2022 D-9/ ASHE WORKSHOP

JOINT MGMT/ IIC COUNCIL QUALITY EFFORT

To identify focus areas where the potential for quality improvements may exist that would provide mutual benefit to both Design and Construction

EXAMPLE #1

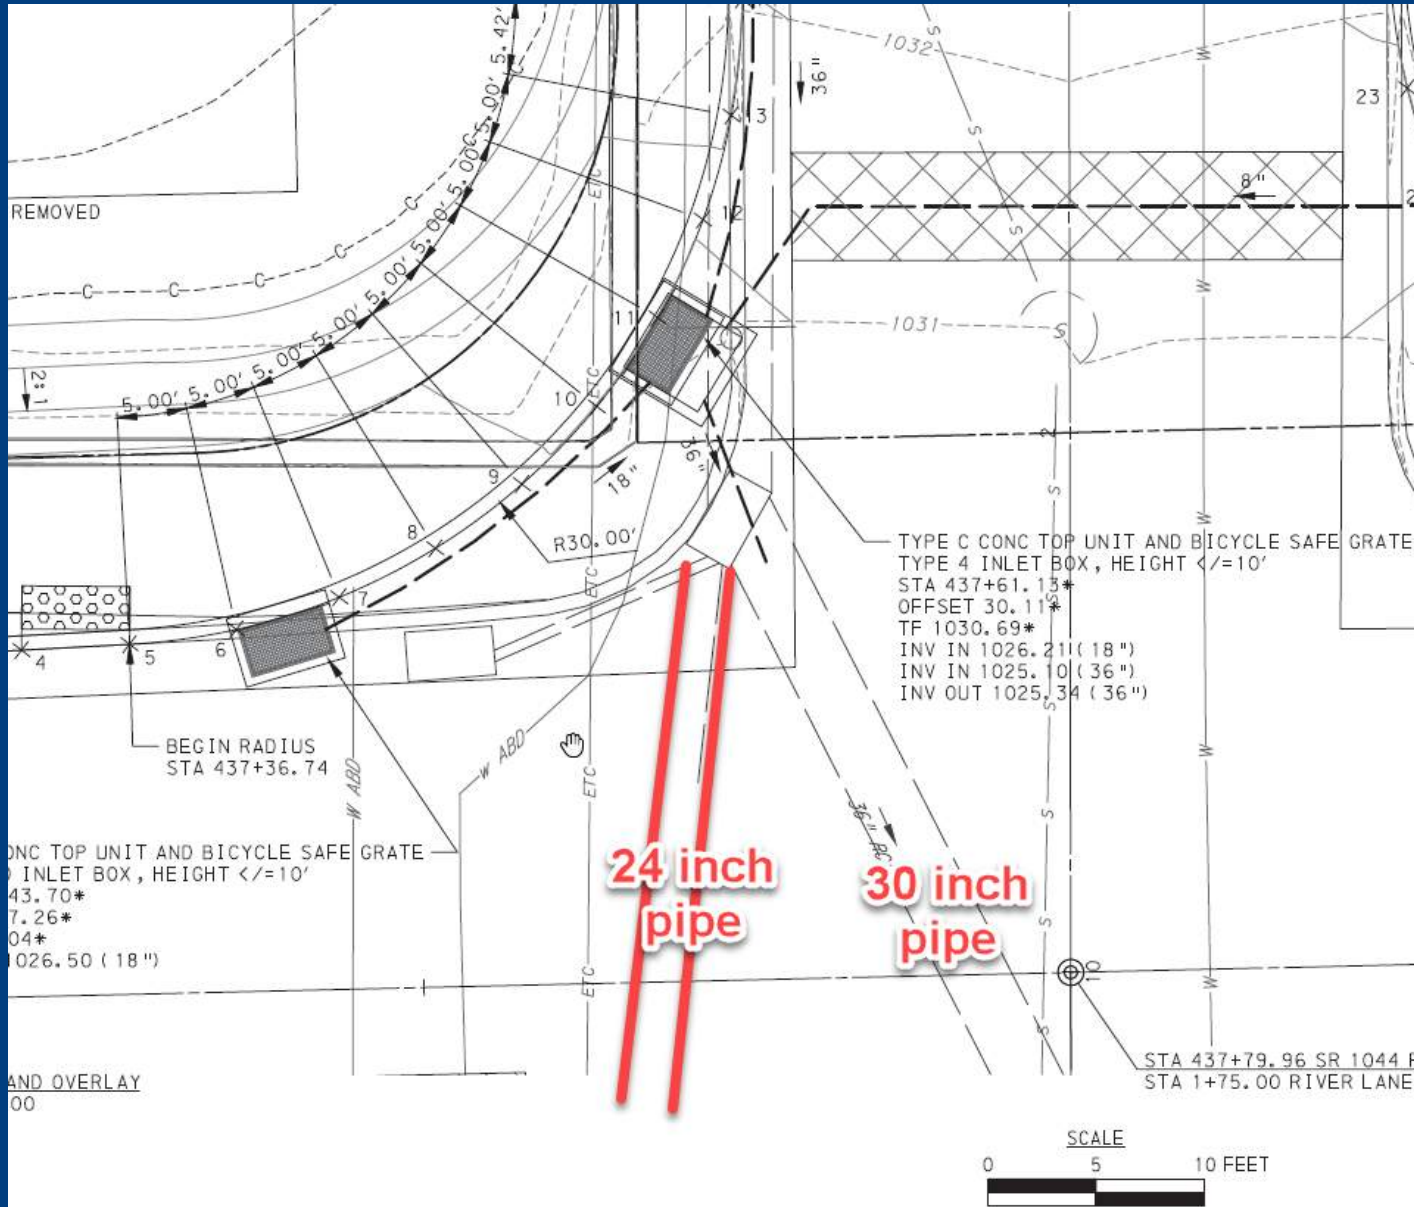
- Plan shows existing 36-inch pipe and 18-inch pipe coming into existing inlet box, with one 36-inch pipe going out
- New inlet box called out as Type 4, but with 36-inch pipe on such a skew needed a larger box
- Ordered larger box for 36-inch pipe on sharp skew instead of Type 4

EXAMPLE #1 (cont.)

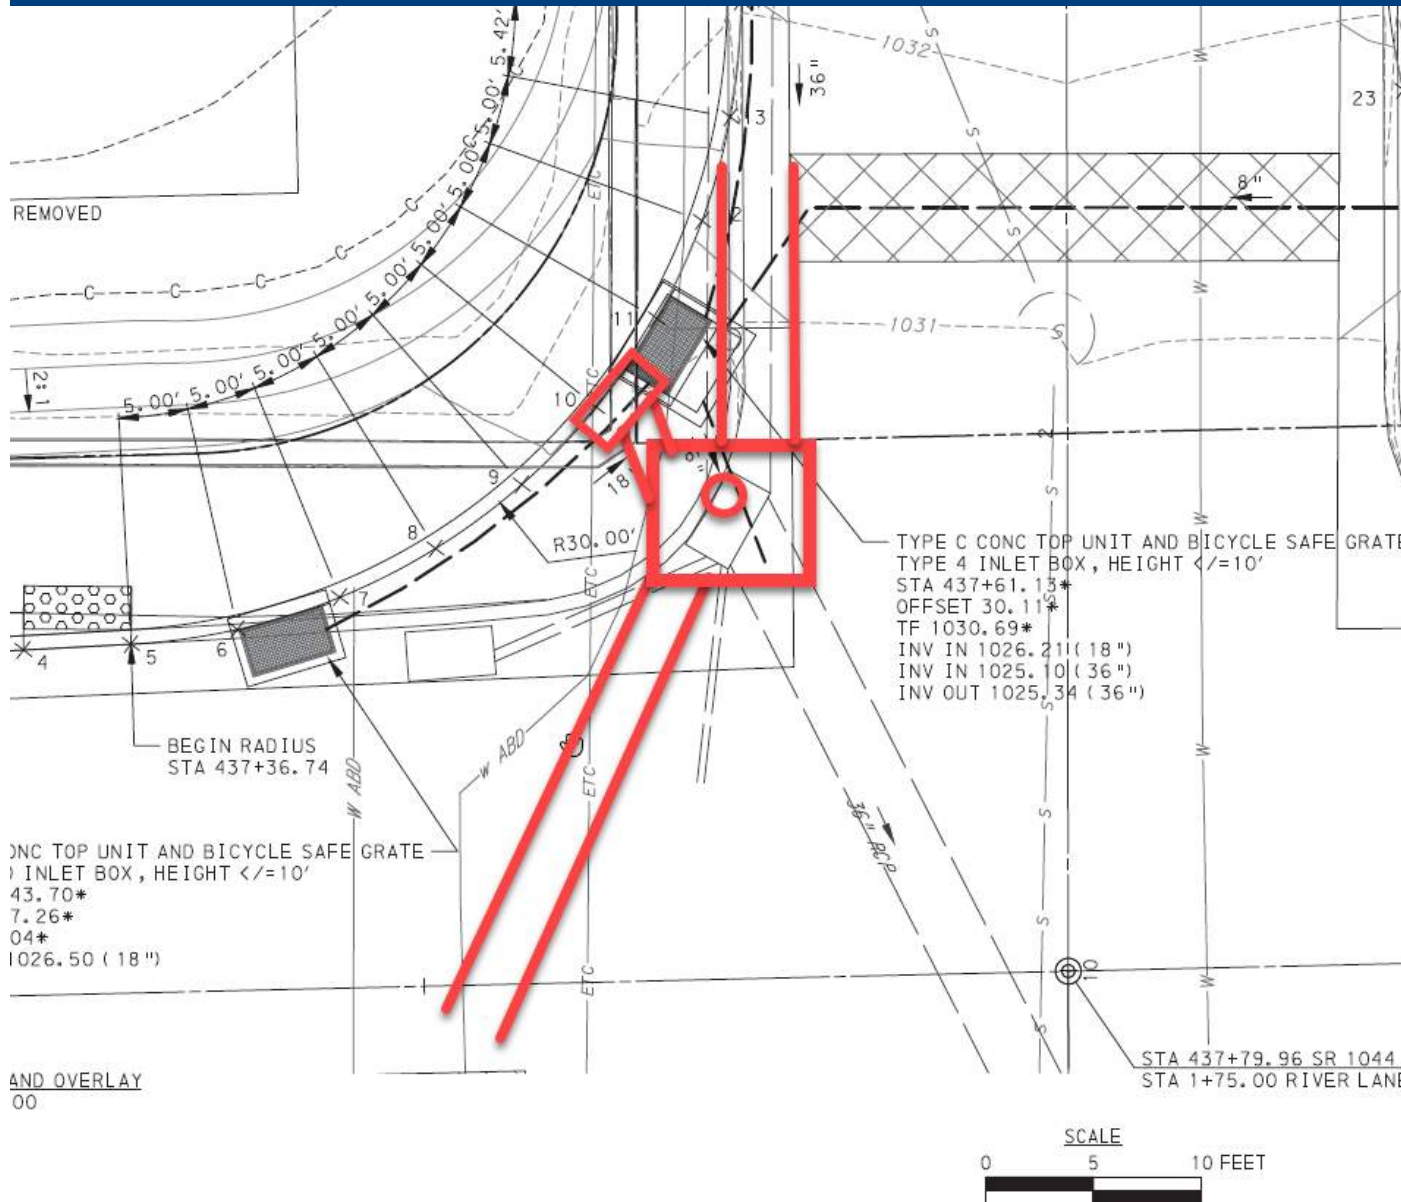
- Actual condition at existing inlet box
- Left outlet pipe 30-inch concrete (not 36")
- Right outlet pipe 24-inch concrete
- Both were needed and functional
- This changed the entire approach
- Field staff scrambling to make decisions on what to do with traffic control

EXAMPLE #3

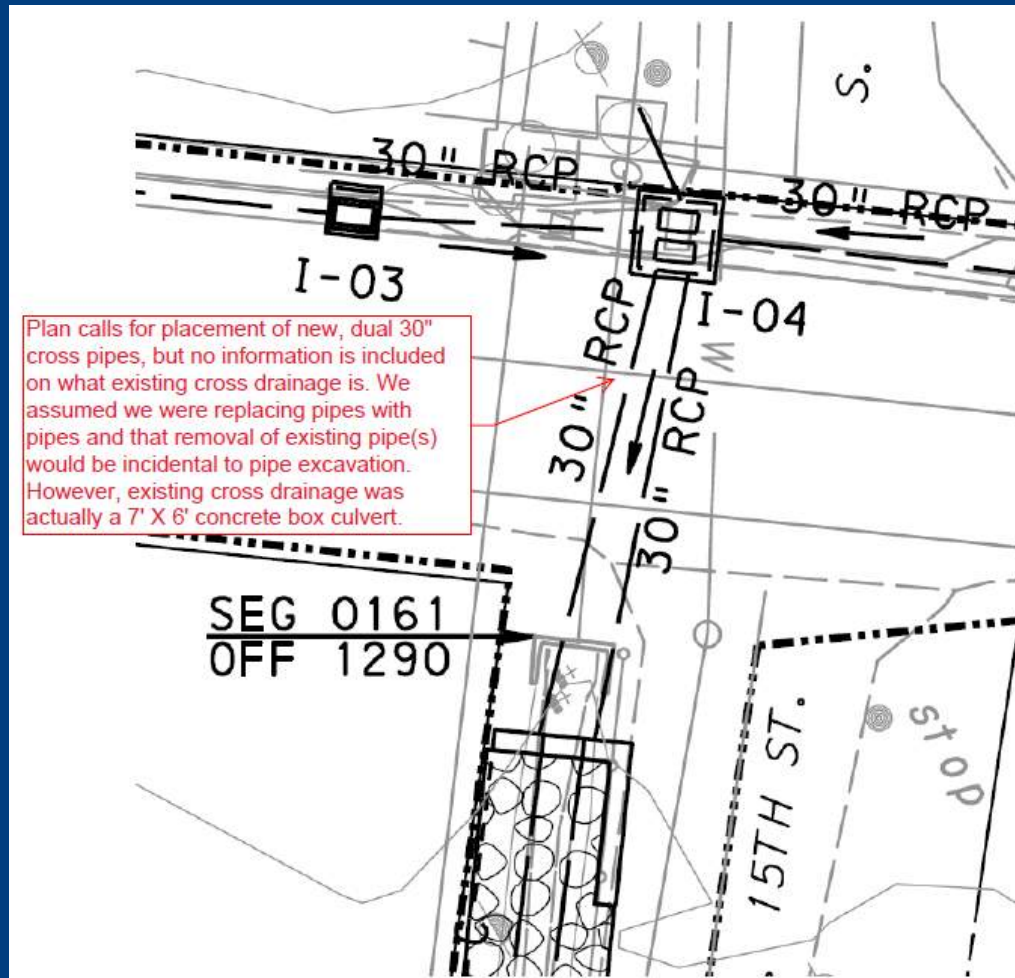
- Plans called to replace the existing cross drainage with two 30" pipes, but no call out indicating what existing cross drainage consisted of
- Existing cross drainage was found to be a 7' X 6' concrete box culvert
- Although removal of small existing pipes would be incidental to pipe excavation, structure demolition (i.e. ~ box demolition) is not incidental
- There was no item for structure demolition to remove the box
- Department had to add a demolition item with long-term traffic control to enable the work to be completed in a safe manner (Cost ~ \$27K , Delay ~ two weeks)

EXAMPLE #5

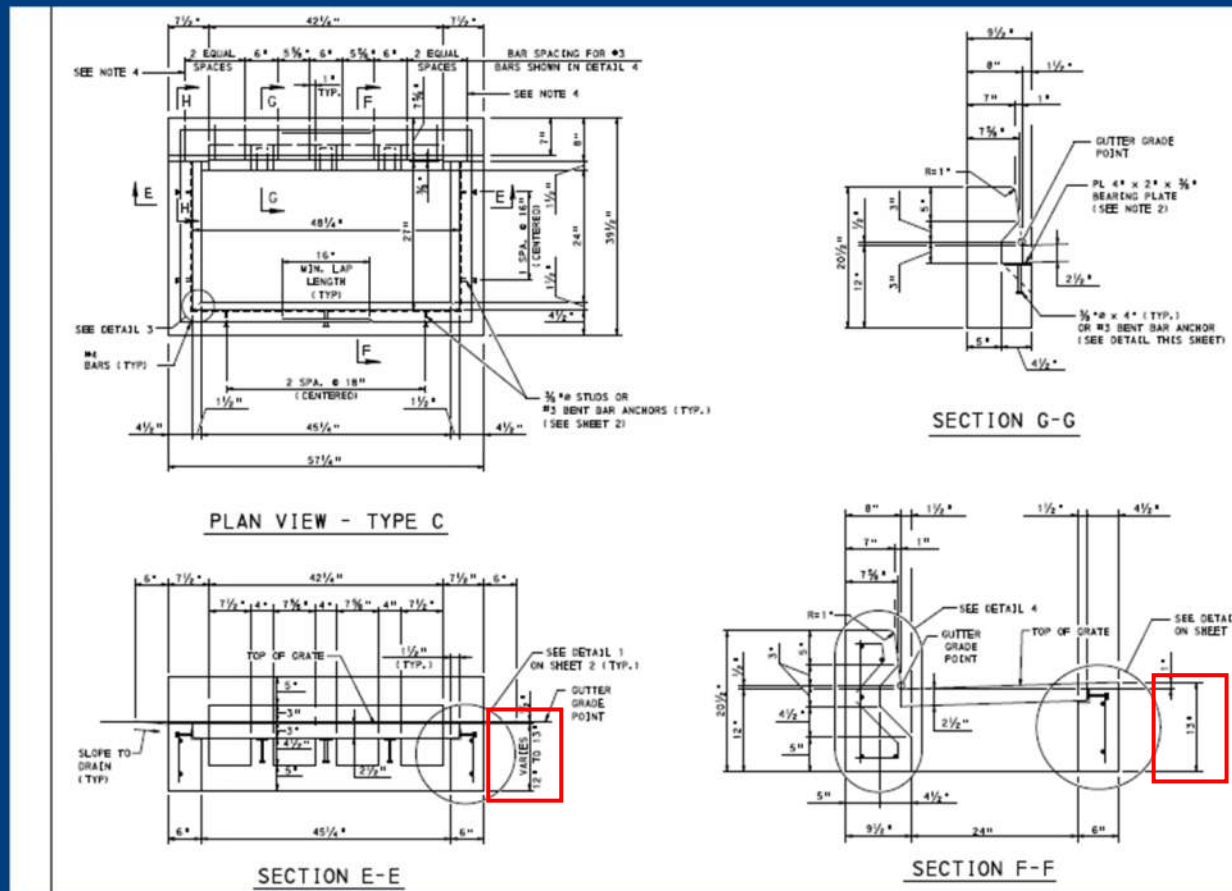
- New Type C Inlet Tops utilizing existing grates were planned. Old tops were 8" depth. Current RC-45M Type C inlet tops are 13" in depth.

- Special provision/ details required to provide alternate inlet tops or provide a grade adjustment of existing inlets item

- In this case, work order was processed for adjusting inlet grades to accept standard top at a cost of \$800 per inlet (luckily, contractor accepted Allied Contract pricing in lieu of force account)

EXAMPLE #6

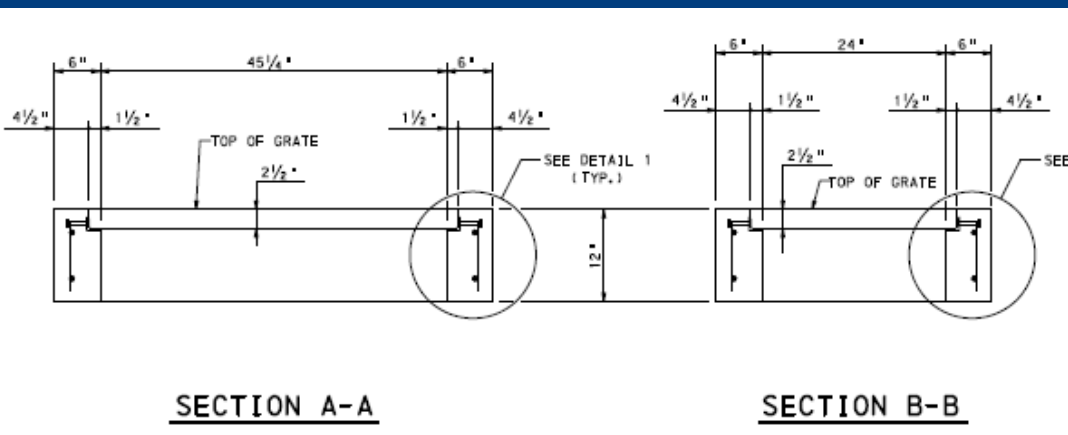
- Corridor improvements project calls for installation of precast Type M Inlet Tops on existing inlets in curbed section
- Due to 4" width of concrete around the perimeter prior to the inlet grate, water will bypass inlet between curb and grate

EXAMPLE #1

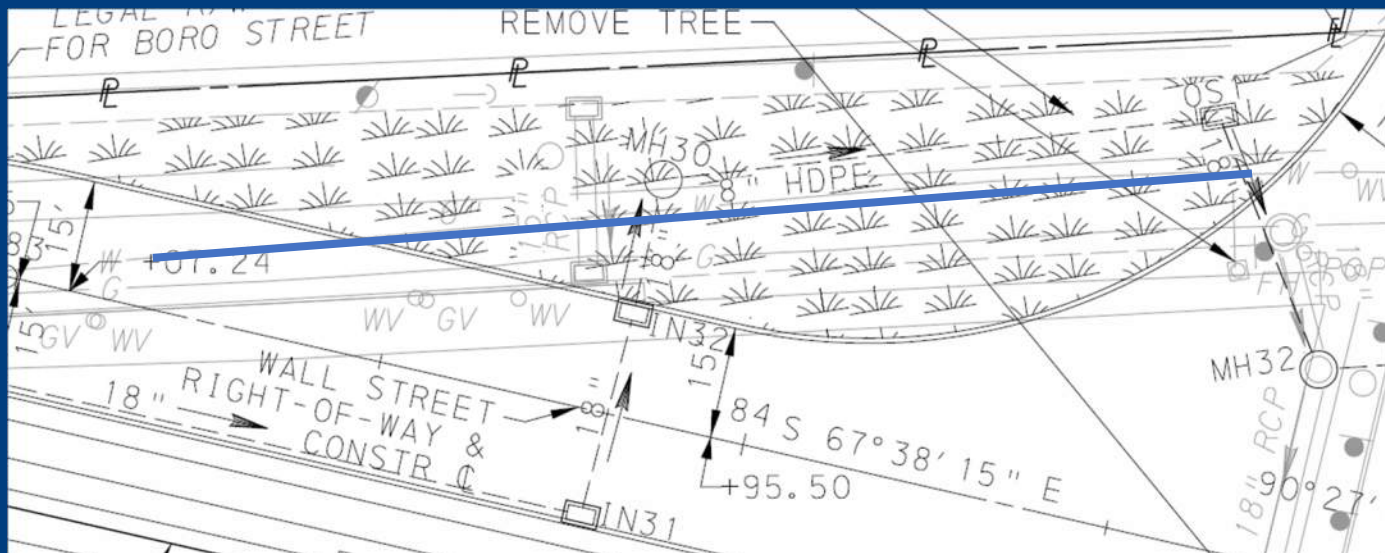
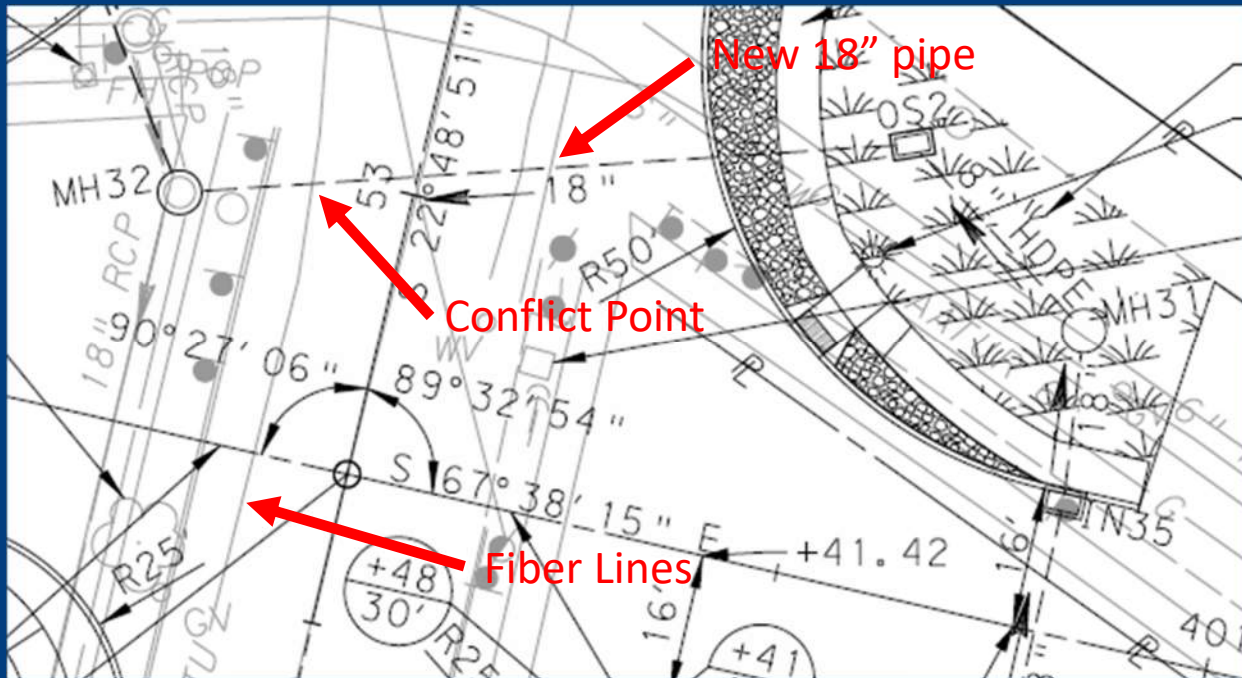
- An existing 6" waterline is shown on the plan view, but not shown on the cross sections
- This waterline ended up being near the bottom of a new infiltration trench whereby the active waterline would be exposed/undermined during trench construction
- The waterline was also in conflict with an 18" pipe to be installed

- END RESULT: Waterline was relocated adding delay and cost to the project

EXAMPLE #2

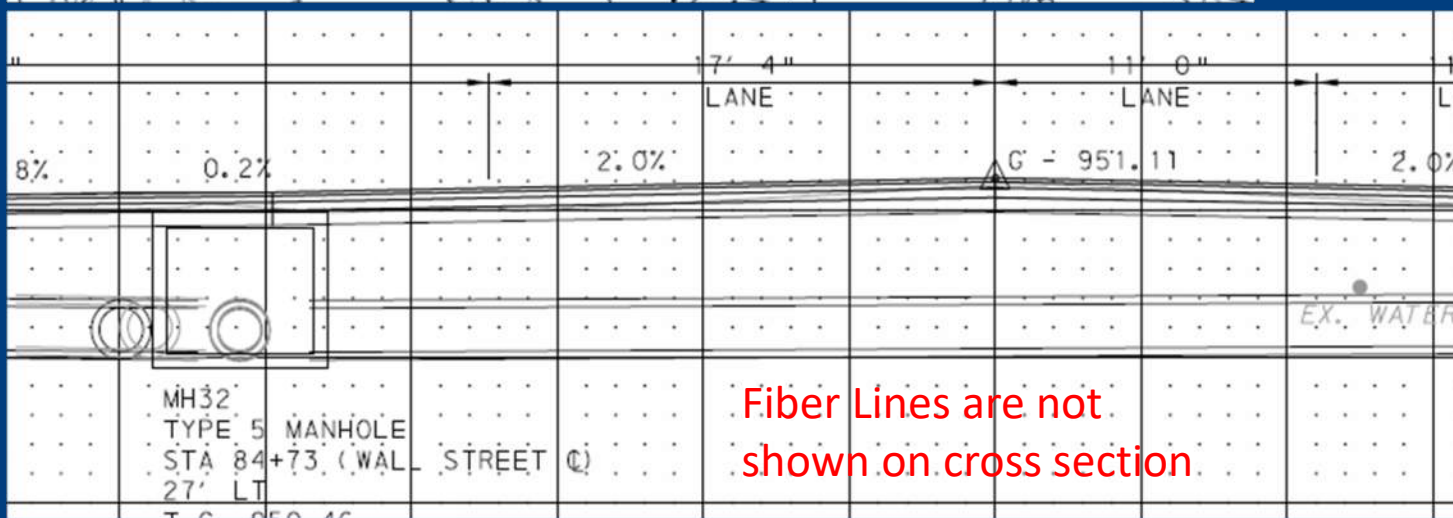
- Existing fiber optic lines are shown on the plan view, but not shown on the cross sections
- An as designed drainage pipe was to connect to existing drainage
- While excavating, it was found that existing fiber optic lines were in conflict with the pipe

EXAMPLE #3

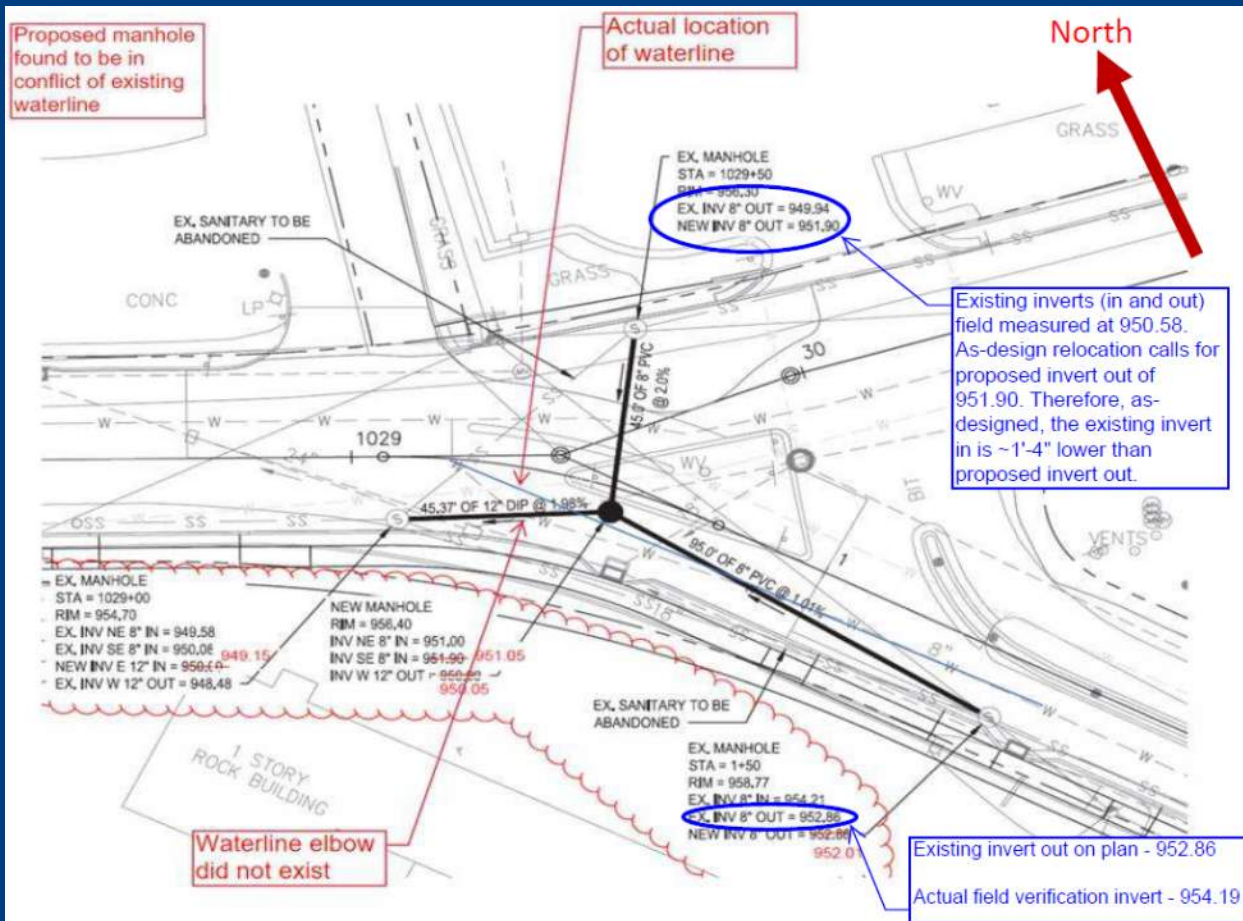
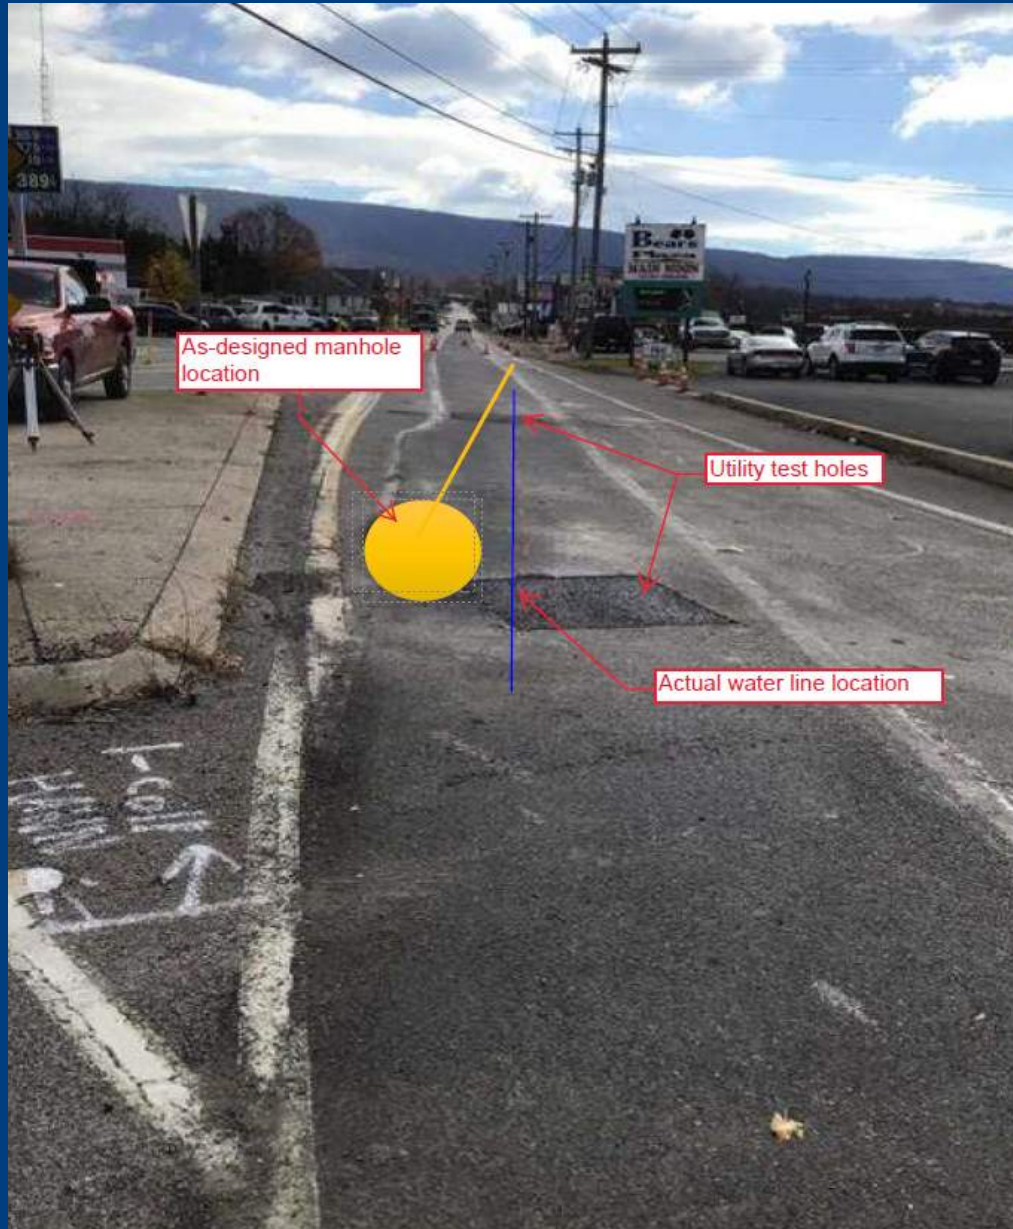
- \$4.2M safety improvement project includes incorporated sewer line relocation work
- Contractor plans to start sewer relocation shortly after NTP on 11/21/21 (before local bituminous plant closes for season) to be set to go with intersection work in the spring
- Ten days before NTP issued, utility meeting held with sewer and water authorities
- As part of meeting and to confirm aspects of the work, manhole covers were opened and it immediately became apparent several existing inverts as shown on the plans were off significantly (see in blue)
